Prairie Island Nuclear Generating Plant Units 1 and 2  
Docket Numbers 50-282 and 50-306  
Renewed Facility Operating License Nos. DPR-42 and DPR-60

Responses to Requests for Additional Information Regarding Prairie Island Nuclear Generating Plant's Overall Integrated Plan Submitted in Response to March 12, 2012 Commission Order Modifying Licenses with Regard to Requirements for Reliable Spent Fuel Pool Instrumentation (Order Number EA-12-051) (TAC Nos. MF0832 and MF0833)

**Responses to Requests for Additional Information Regarding  
Reliable Spent Fuel Pool Instrumentation  
(Order EA-12-051)**

**Revised Figure 2 – Simplified Elevation Sketch of Levels (Not to Scale)**

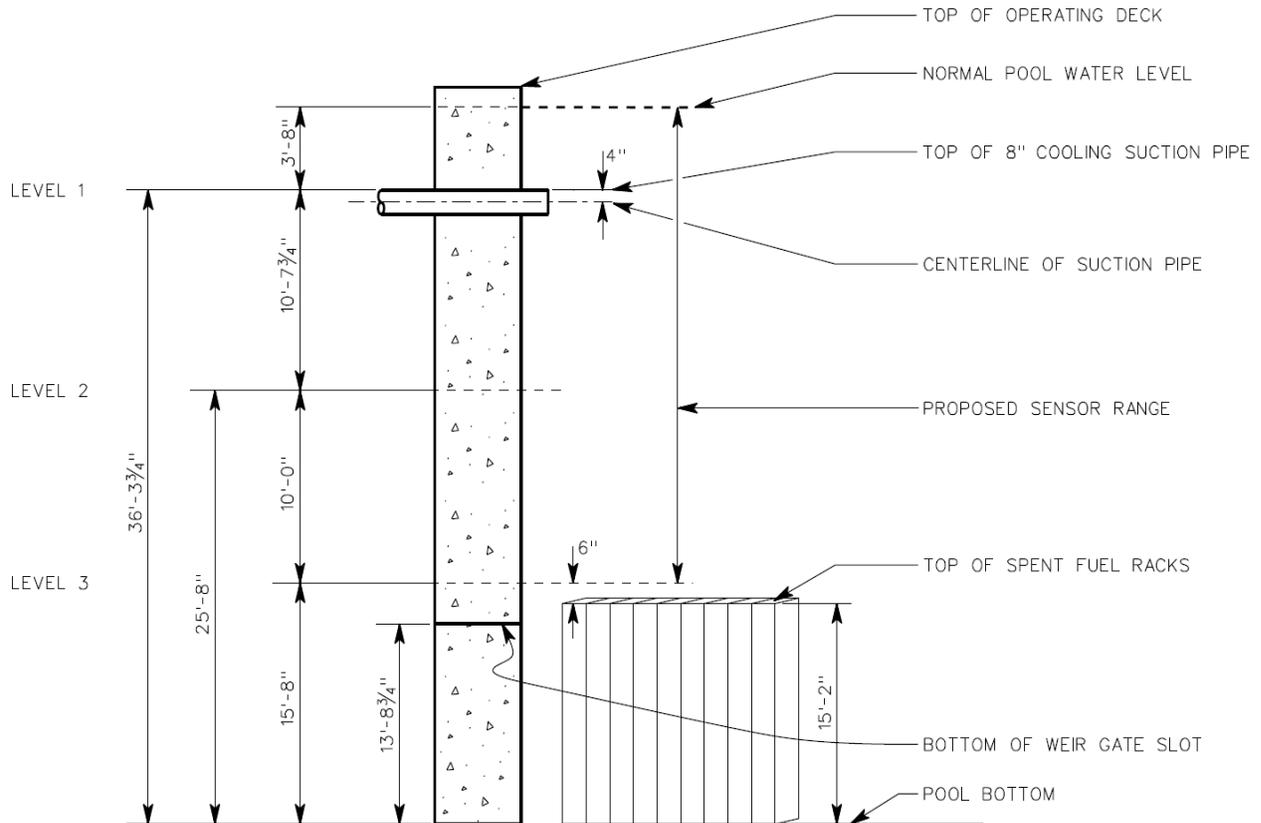
- a) For level 1, specify how the identified elevation represents the HIGHER of the two points described in the NEI 12-02 guidance for this level.*
- b) For Figure 2, indicate the portion of the level sensor measurement range that is sensitive to measurement of the fuel pool level, with respect to the Level 1, Level 2, and Level 3 datum points.*
- c) The OIP states, in section 3.3, Mounting, "An evaluation of other hardware stored in the SFP will be conducted as part of the detailed design to ensure it will not create adverse interaction with the fixed instrument locations." Please provide a discussion regarding dose rates for stored spent fuel versus that of other material that may be stored in the pool.*

- b) Figure 2 from the original OIP has been revised to indicate the proposed level sensor range as shown below. The proposed level sensor range will indicate from Level 3 up to the normal pool water level. NSPM's current plan is to begin design of the SFPI system by the end of September 2013, with design completion expected by the end of January 2015. Any changes to the requested information on level sensor range will be provided with the February 2015 six-month status report.

**Revised Figure 1 – Spent Fuel Pool General Layout (Not to Scale)**

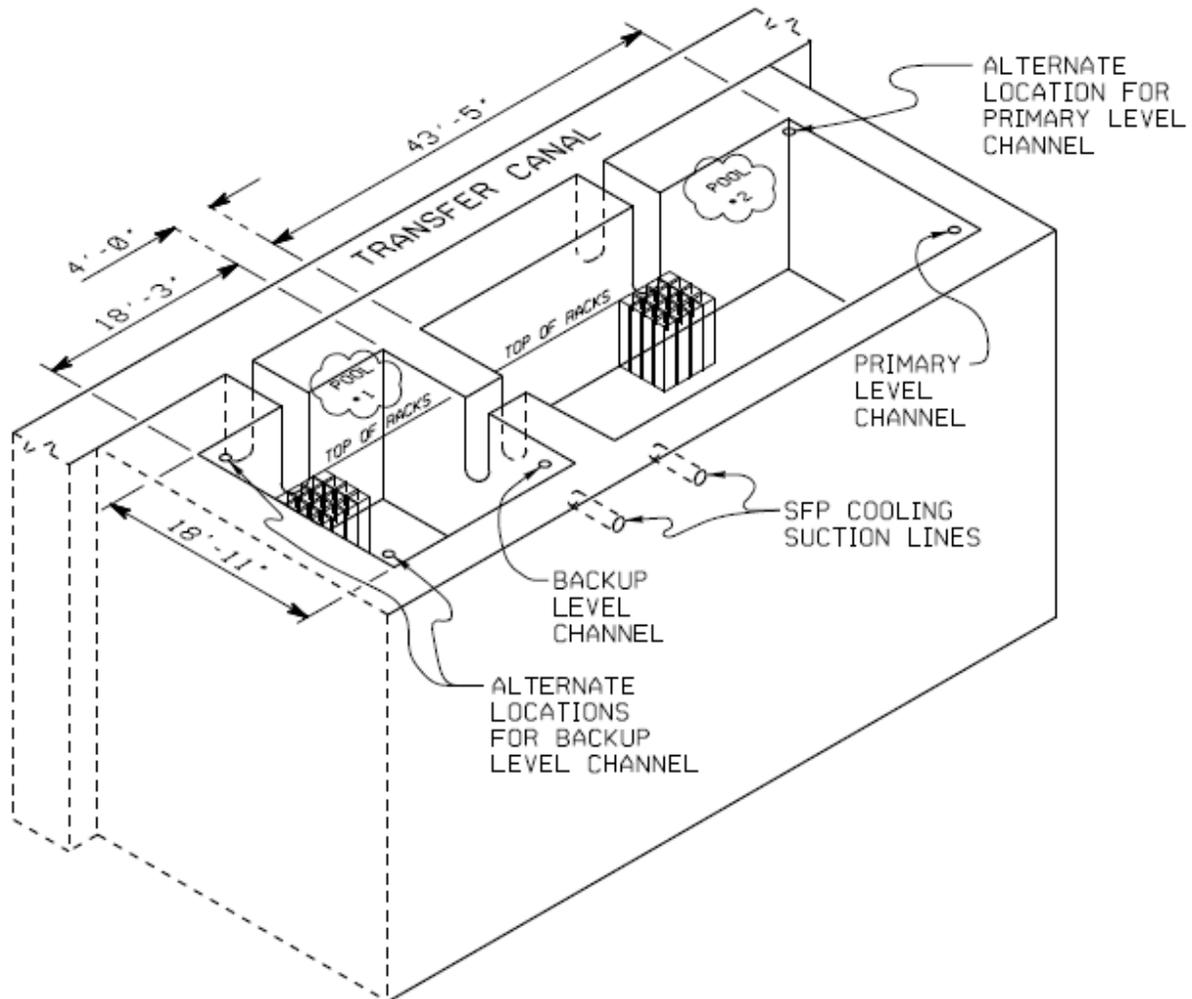
*Please modify the sketch in Figure 1 or provide a marked-up plant drawing of the plan view of the spent fuel pool area, depicting the spent fuel pool inside dimensions, the planned locations/ placement of the primary and back-up spent fuel pool level sensors, and the proposed routing of the cables that will extend from the sensors toward the location of the local electronics cabinets and read-out/display devices in the main control room or alternate accessible location.*

The sketch provided as Figure 1 in the original OIP has been revised to provide the spent fuel pool inside dimensions. Revised Figure 1 is provided below. The proposed locations/ placement of the primary and back-up spent fuel pool level sensors remain on the revised Figure 1 sketch provided below. The proposed routing of the cables has not been determined. The final component locations and cable routing will be available upon completion of the final design. NSPM's current plan is to begin design of the SFPI system by the end of September 2013, with design completion expected by the end of January 2015. The requested information will be provided with the February 2015 six-month status report.
